COPPERSTRING EIS

Attachment F - Vegetation Clearing Works plans

Flinders Substation to Dajarra Road Substation

FLR-DJR_466

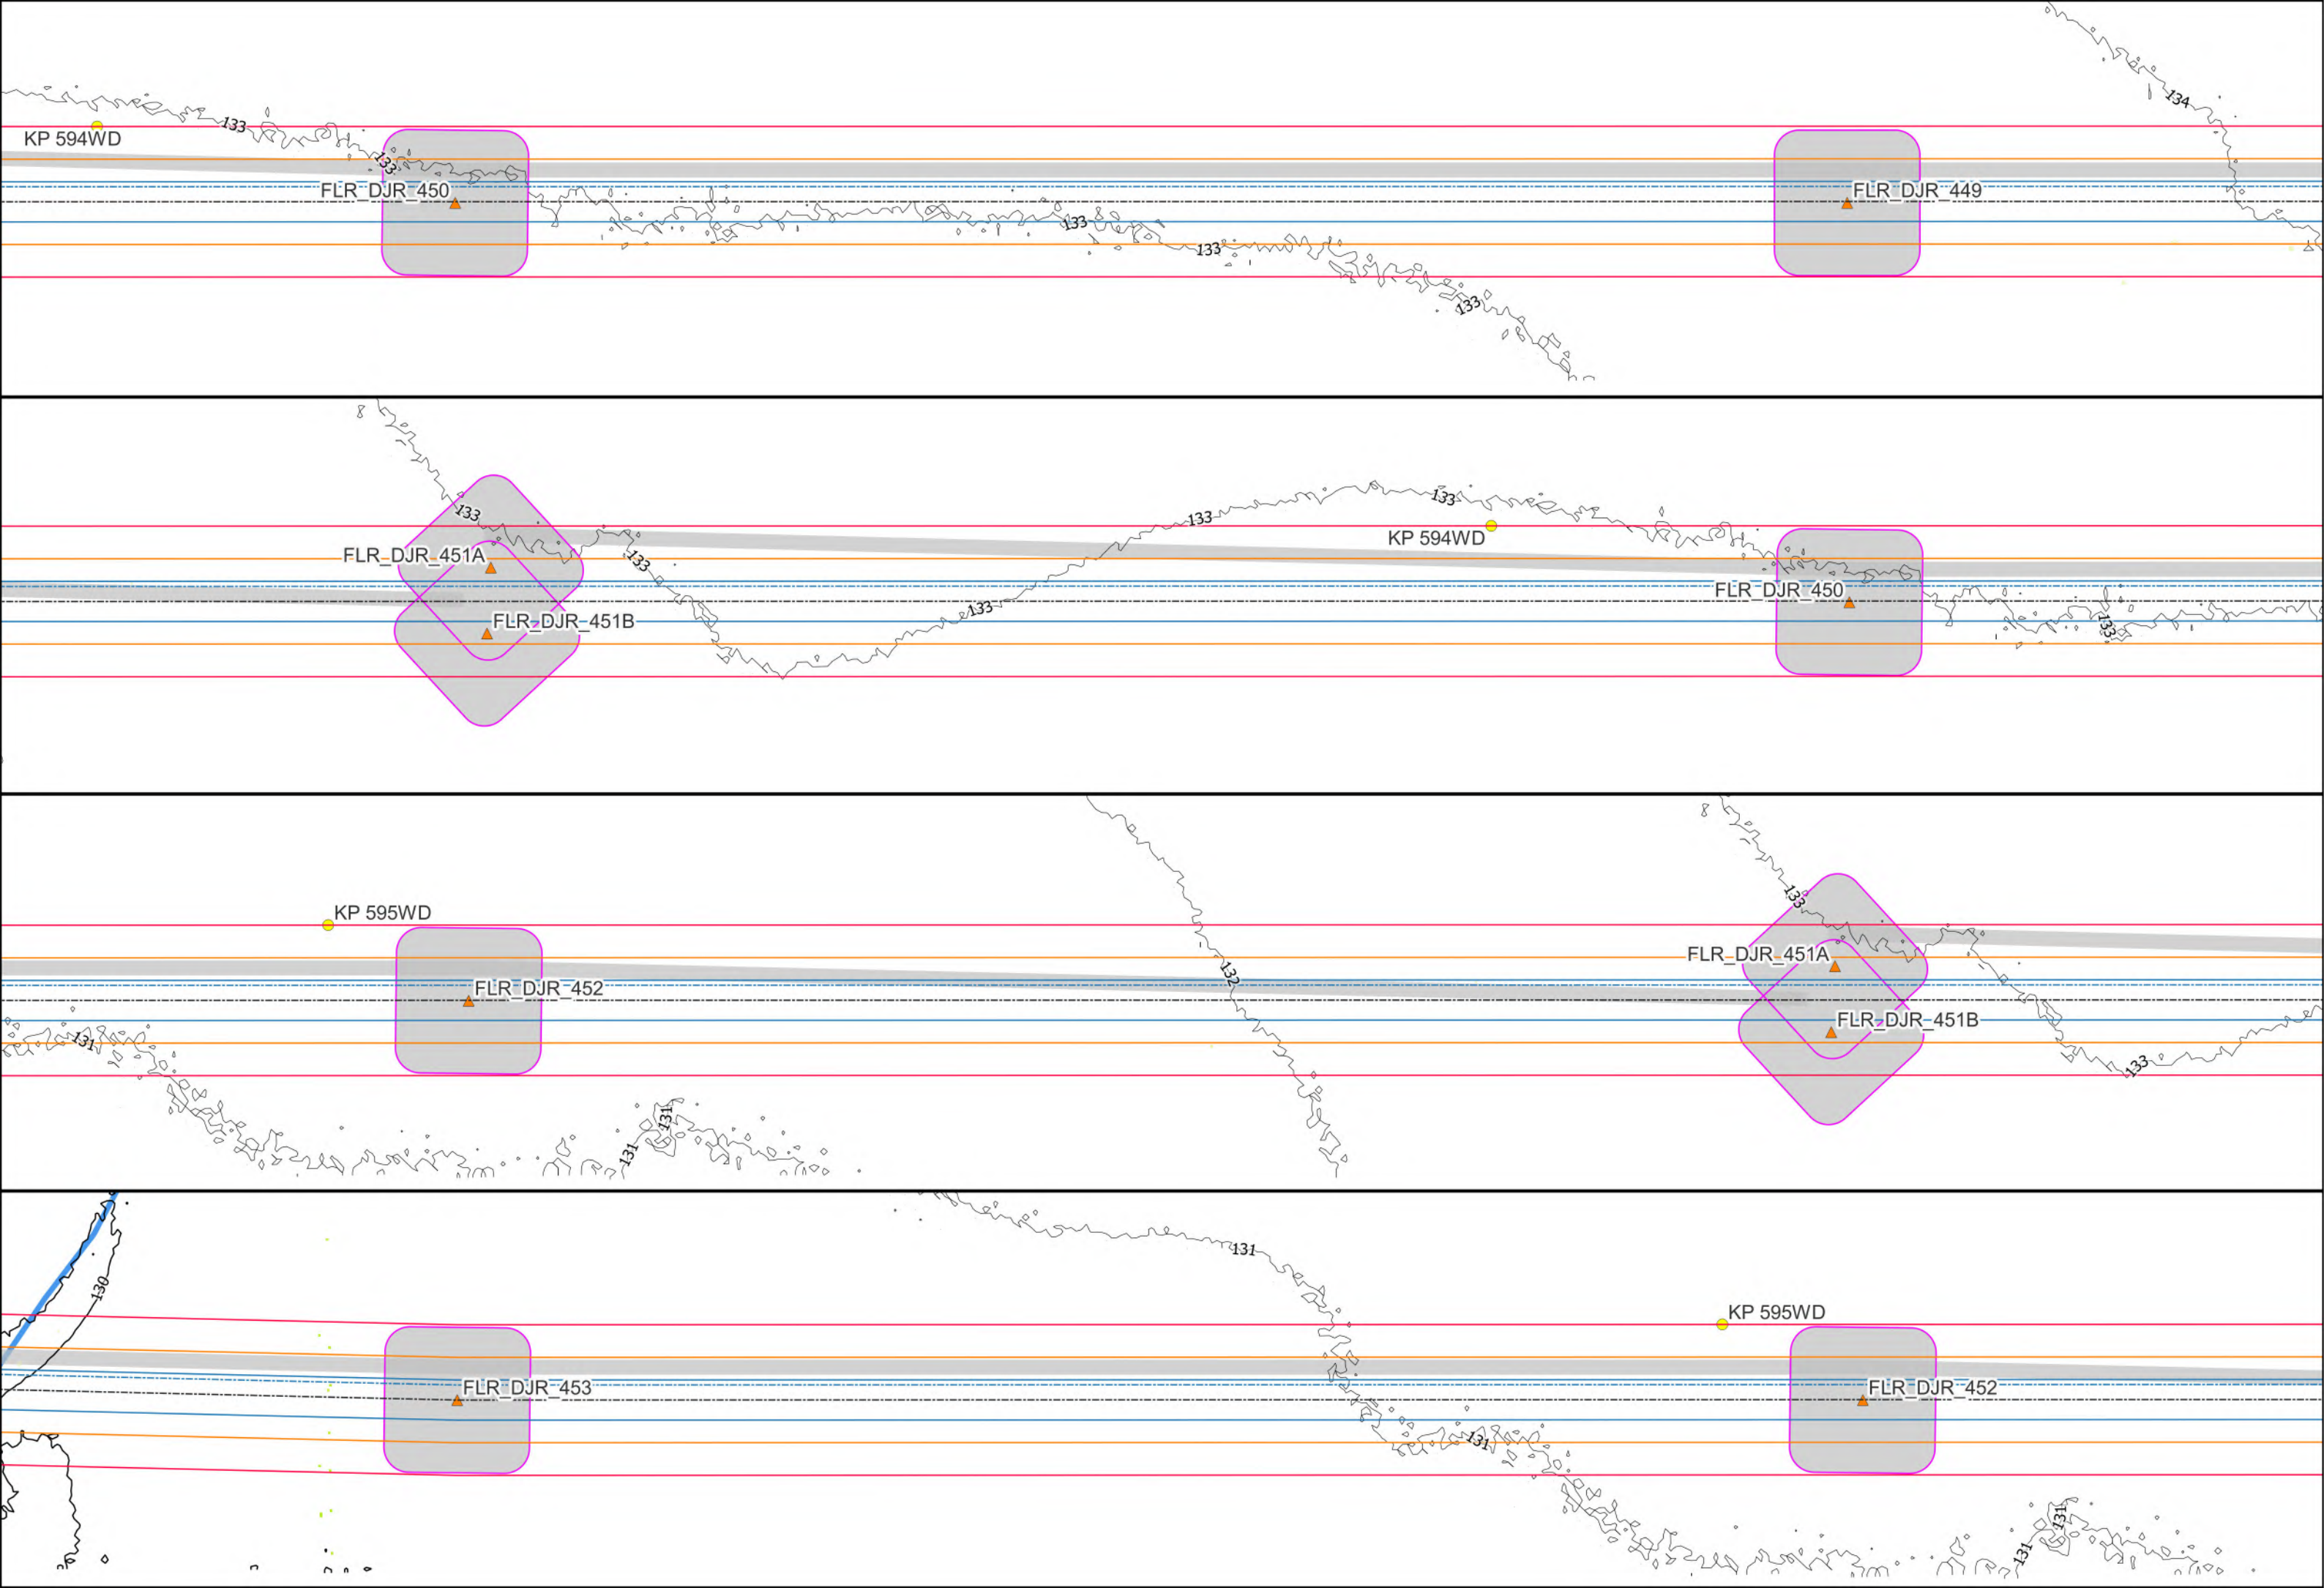
Tower height and placement to be reviewed during detailed design to reduce clearing impacts to waterway. Clearing for conductor clearance to this Major Risk (purple) waterway occur above ground level to minimise disturbance to ground and roots which contribute to bank stability.

Tower assembly area to be reconfigured to not be within 15m of the high bank of waterway and to avoid clearing near or within the bed and banks for the waterway.
